U.S. NUCLEAR REGULATORY COMMISSION  
REGION I

Report Nos.            96-06  
                          96-06

Facility Name:         SUSQUEHANNA STEAM ELECTRIC STATION

Susquehanna Steam Electric Station, Units 1 & 2  
NRC Inspection Report 50-387/96-06, 50-388/96-06

# RWCU Area Steam Leak Detection Room Temperature Instrumentation

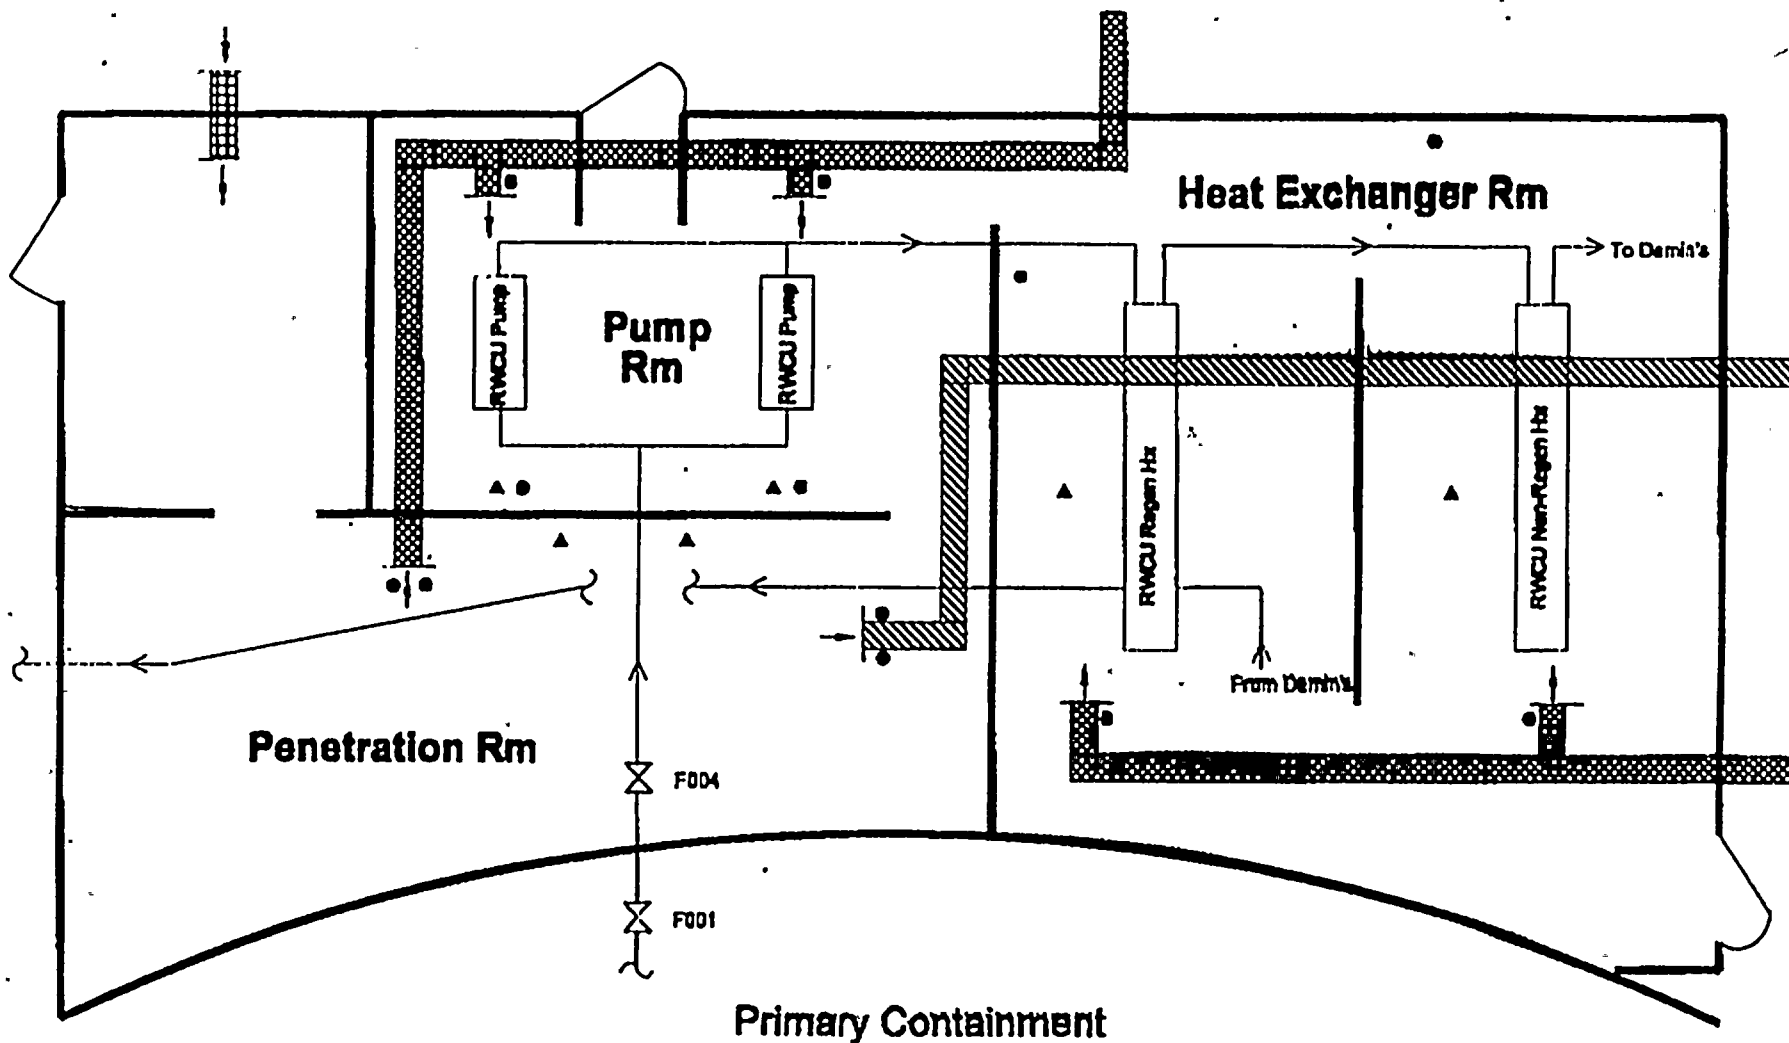
- *NRC Inspection Report: EEI 96-03-01*
  - "...on several occasions since 1988, the licensee did not properly consider the SSES licensing basis either in its assessments of system operability or in implementing compensating measures and corrective actions."
  - "...the FSAR was not updated to reflect changes in the isolation system design basis as required by 10 CFR 50.71(e) (4)."

- *System Design*
  - Significant Redundancy Exists
  - Delta-T Concept Has Weaknesses
  - Penetration Room Configuration  
Complicated Setpoint Calculation
